4.0 PROPOSED DEVELOPMENT

PRINCIPAL CHANGES:

FIG . 60 - BLOCKS A AND B - TYPOLOGY ELEVATIONS AND SECTIONS

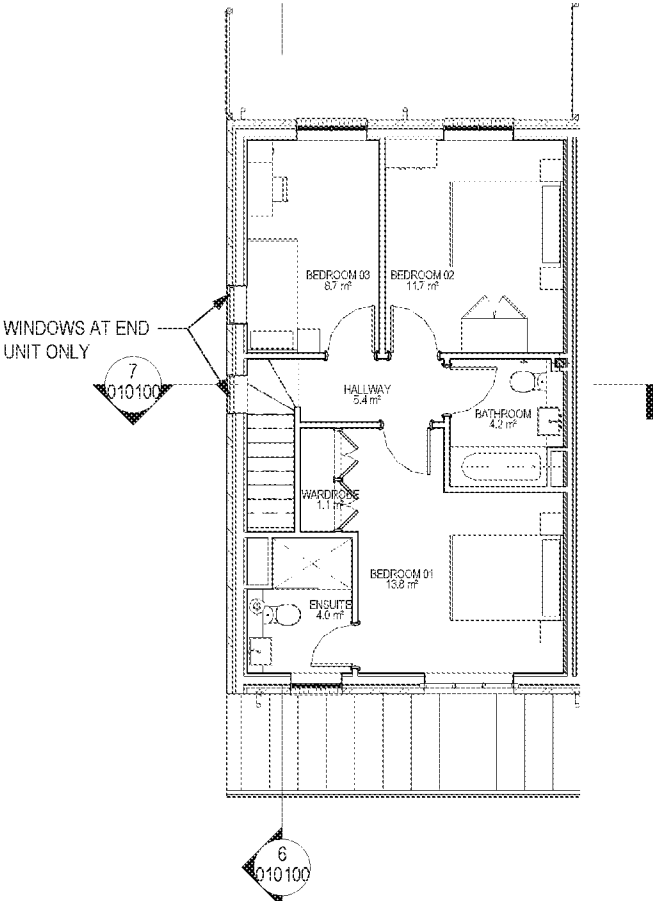
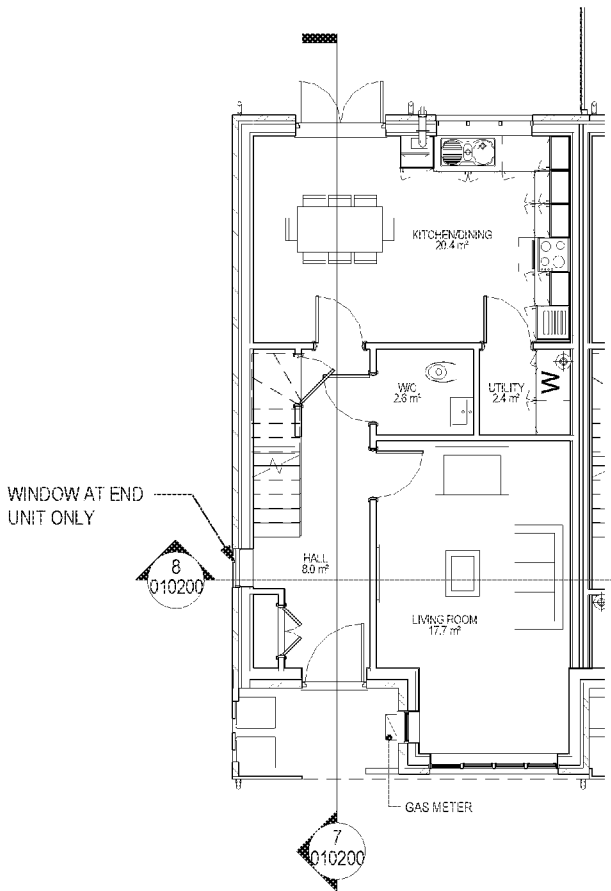
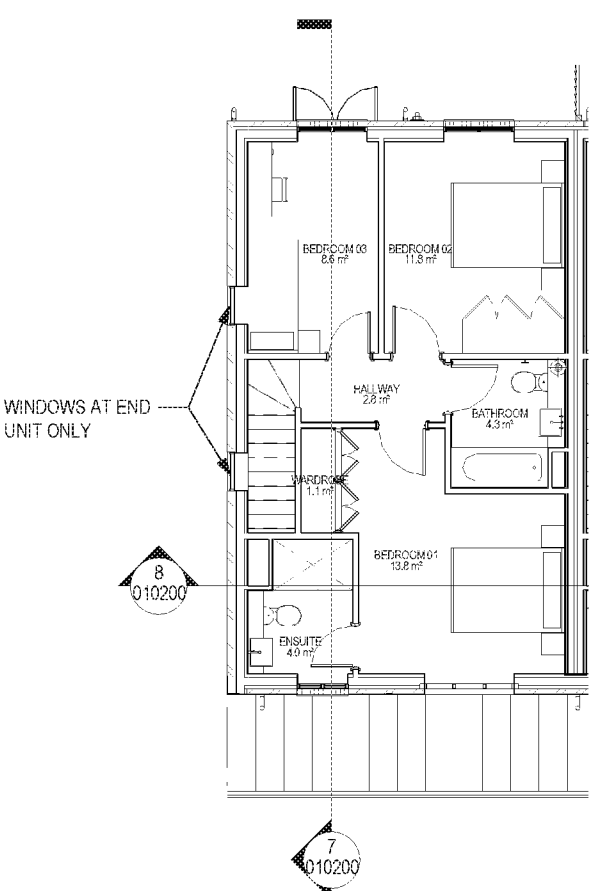
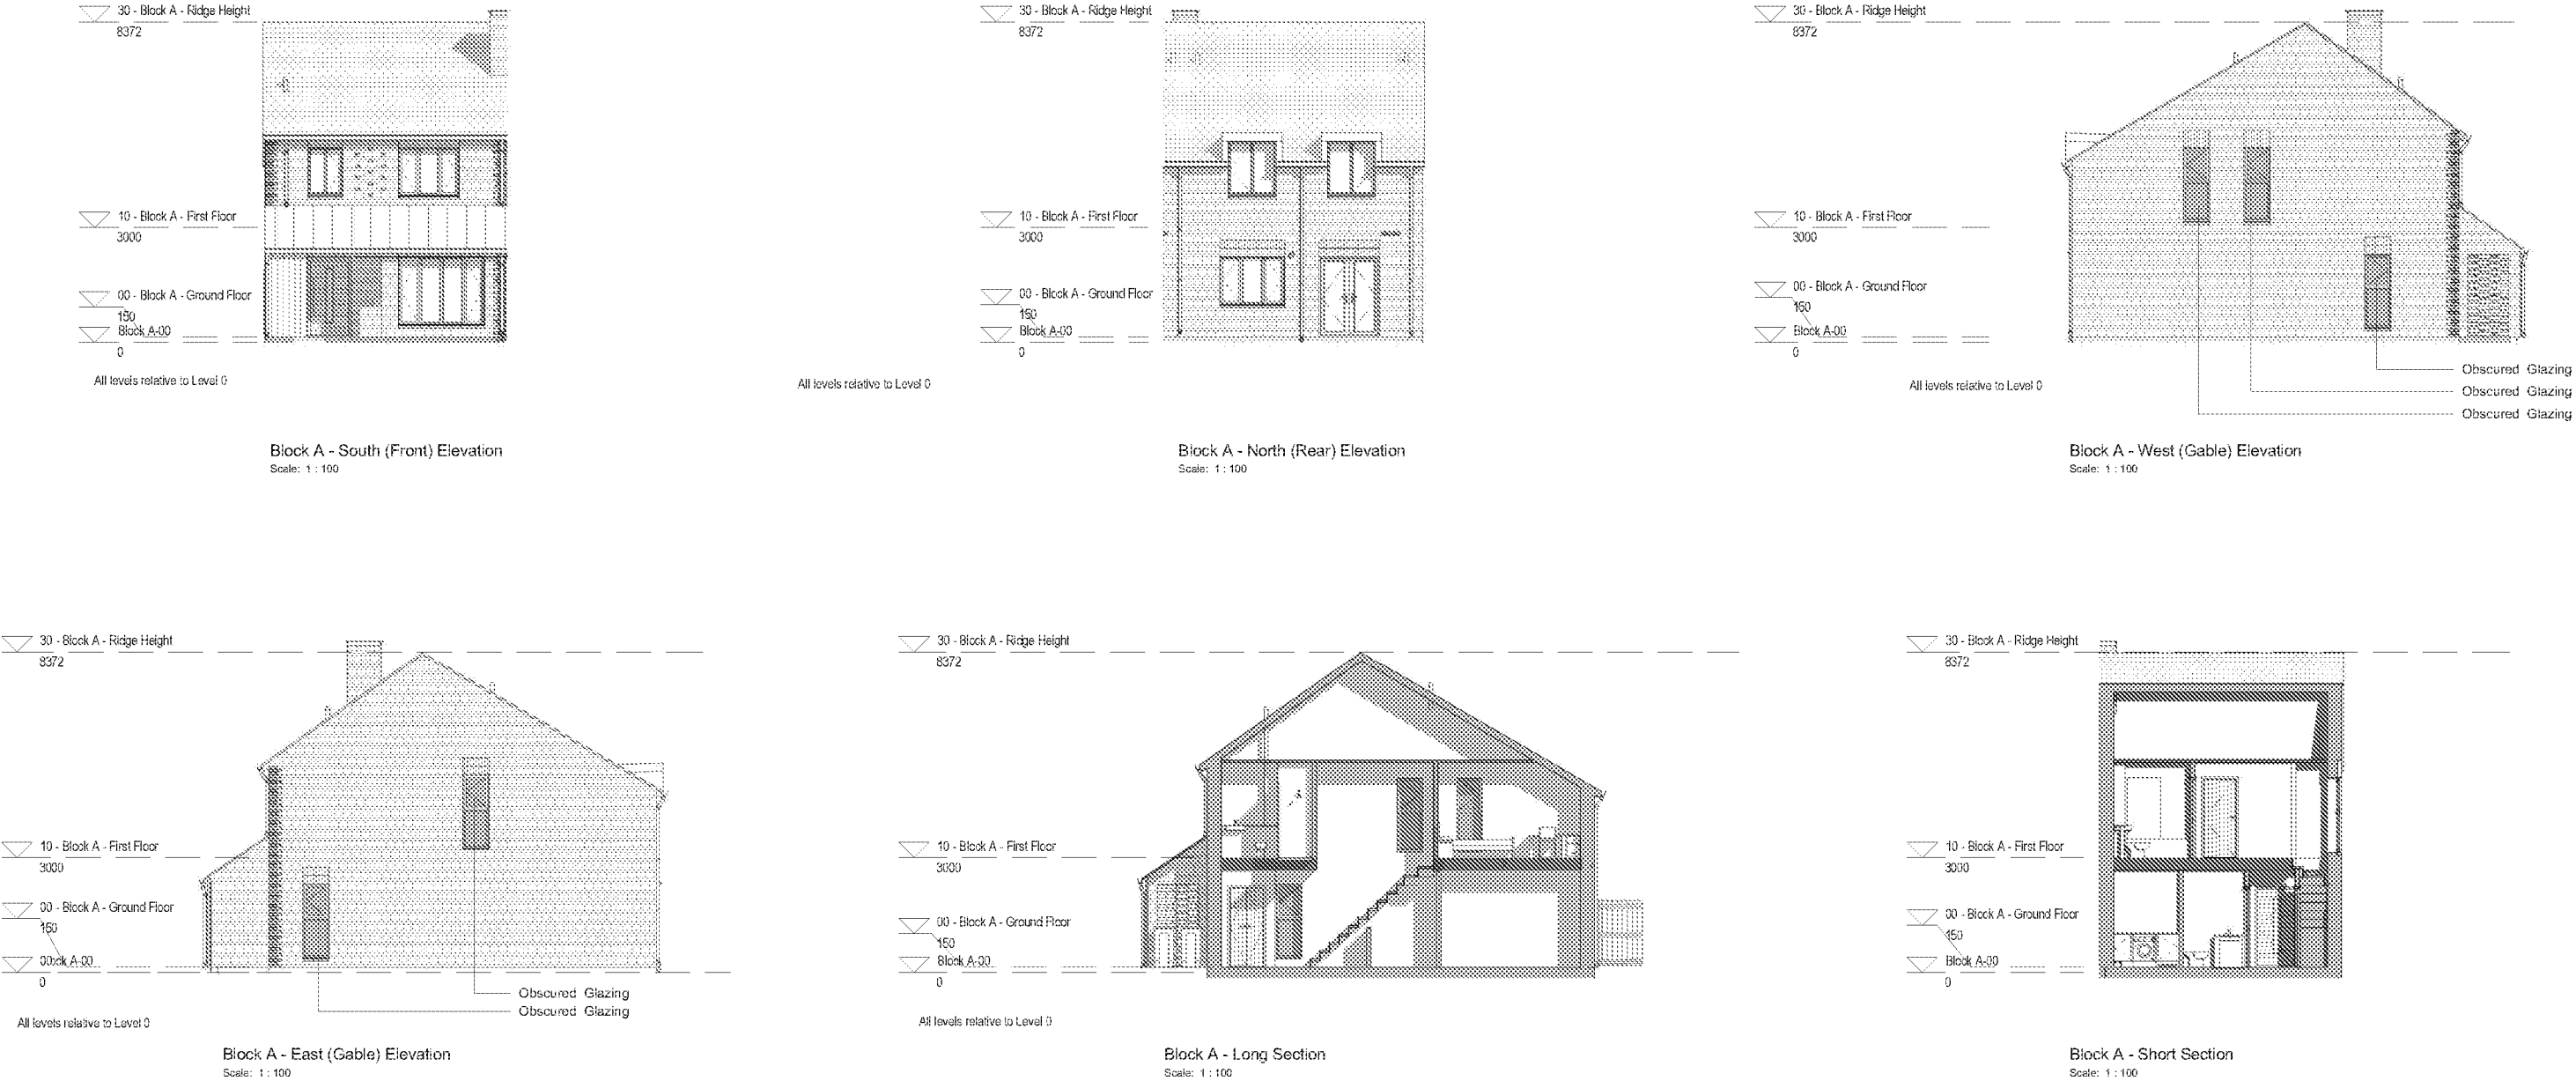
4.8 HOUSE TYPE 1 - BLOCKS A & B

The proposed house types in Blocks A and B are externally identical. Internally however we propose to make Block B slightly different on ground floor. The small amendment allows these houses to be wheel-chair adaptable homes complying with Approved Document M4(2) - Category 2 Accessible and Adaptable Dwellings.

The proposed scheme for A & B include:

- Reduction in ground floor area.
- Raising the eaves height to allow for a larger, more use-able first floor plan, while retaining the building height proposed on the consented scheme.
- Additional bay window to allow more natural light into the living room, but also to create a more varied depth and form to the frontage.
- Brick detailing to create texture and reference the historic setting.

FIG . 61 - BLOCK C - TYPOLOGY ELEVATIONS AND SECTIONS

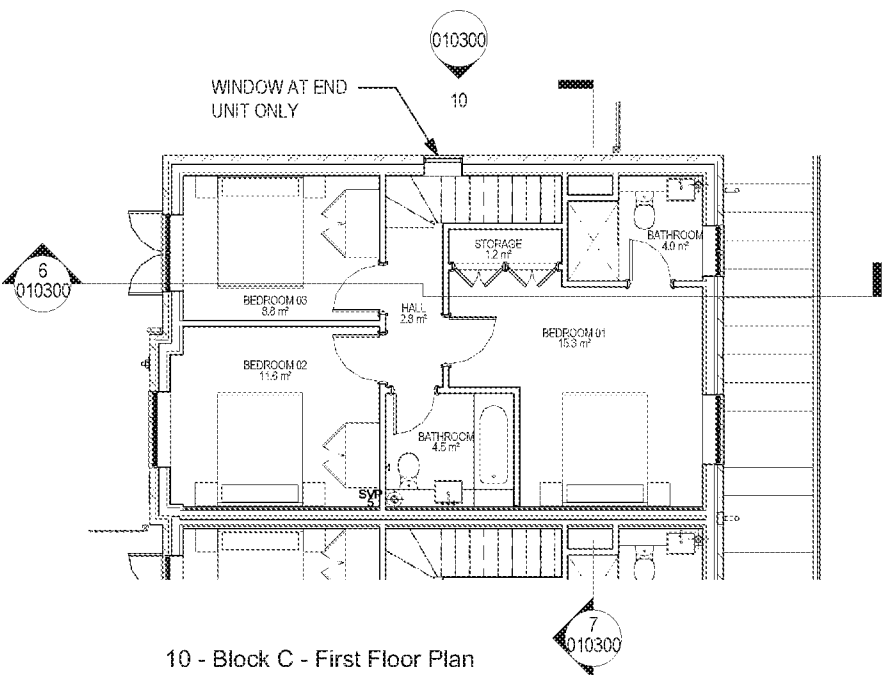
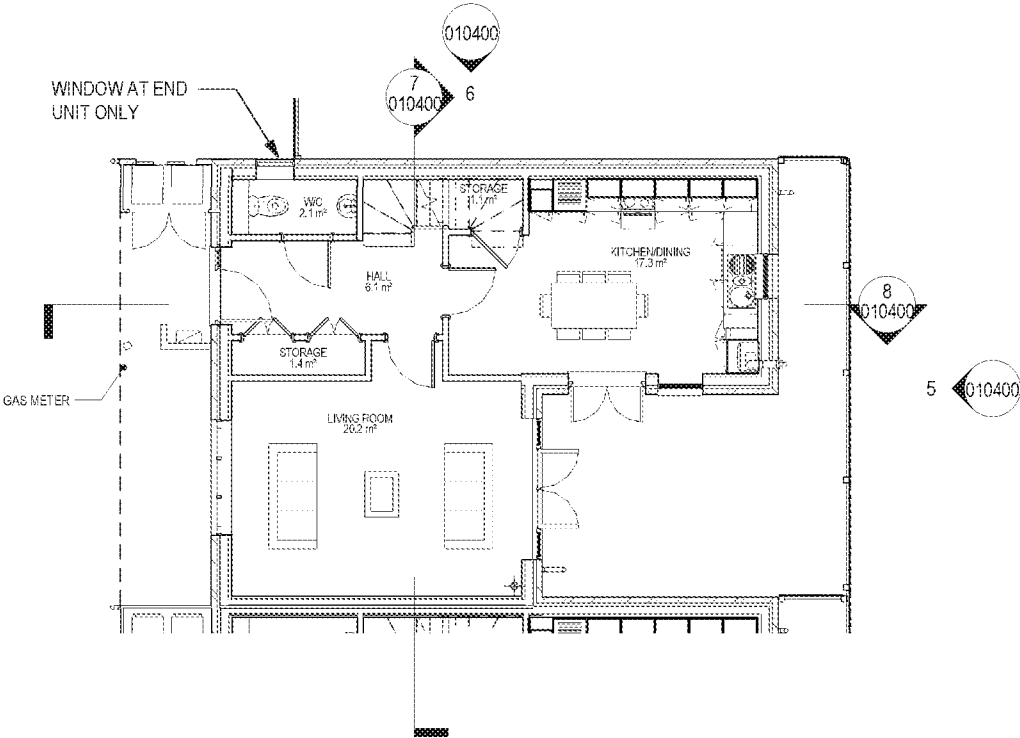
4.9 HOUSE TYPE 2 - BLOCK C

The proposed house type in Block C is similar to Blocks A and to B in that it provides 3 bedrooms. C has been rationalised on the ground floor to create a reduced floor area, allowing the whole block to be reduced. This reduction has not only improved upon the consented schemes layout efficiency but has also allowed an additional unit to be added to the block of homes. As previously discussed, this will increase the viability of the scheme.

- Reduction in ground floor area and therefore, overall mass of block C
- Raising the eaves height and reducing roof pitch to allow for a larger use-able first floor area
- Bay window added to allow more natural light into the single-aspect living room, also giving more varied form to the frontage.
- Brick detailing to create texture and reference the historic setting.
- Additional unit added to the block.

00 - Block D - Ground Floor Plan
Scale: 1 : 100

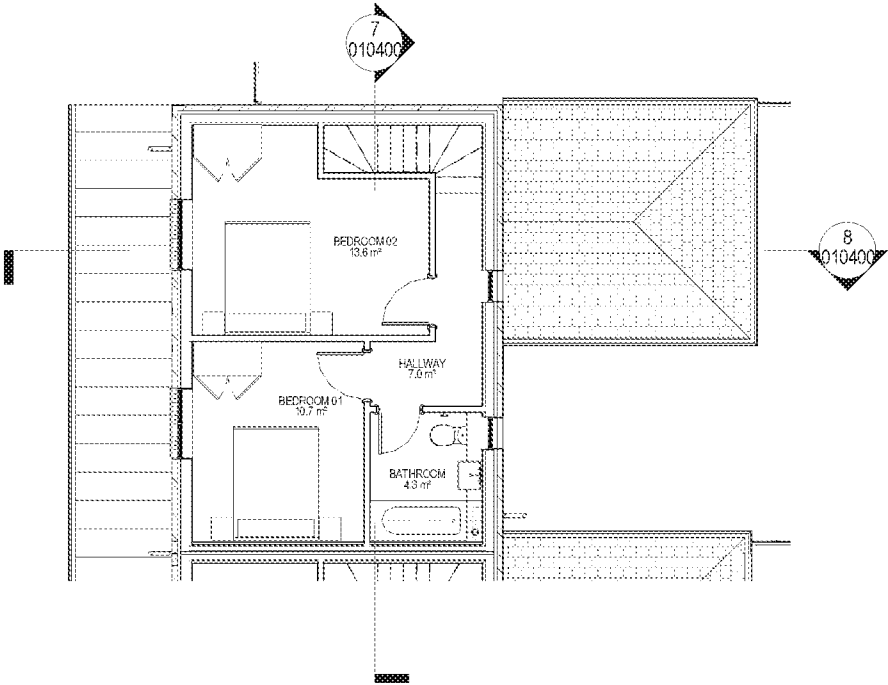
4.10 HOUSE TYPE 3 - BLOCK D

The proposed house type Block D has also been rationalised to allow an overall reduction in the mass of the block and an additional unit has been added. The biggest concern with the consented block D was the distance between the building, the boundary and its neighbours. To mitigate some of this, we have moved block D 1.5m west, from the boundary to create more distance between them. This has also increased the garden size from 11.7m² to 19m².

- Offsetting the block from boundary and block D by increasing the distance by 2.2m, to mitigate the overhanging eaves.
- Increased garden size.
- Reduction in ground floor area and therefore, overall mass of block D.
- Additional unit added to the block.
- Brick detailing to create texture and reference the historic setting.
- Raising the eaves height and reducing roof pitch to allow for a larger use-able first floor area
- Reducing the size of the windows facing the neighbours and making the one in the bathroom obscure to improve privacy
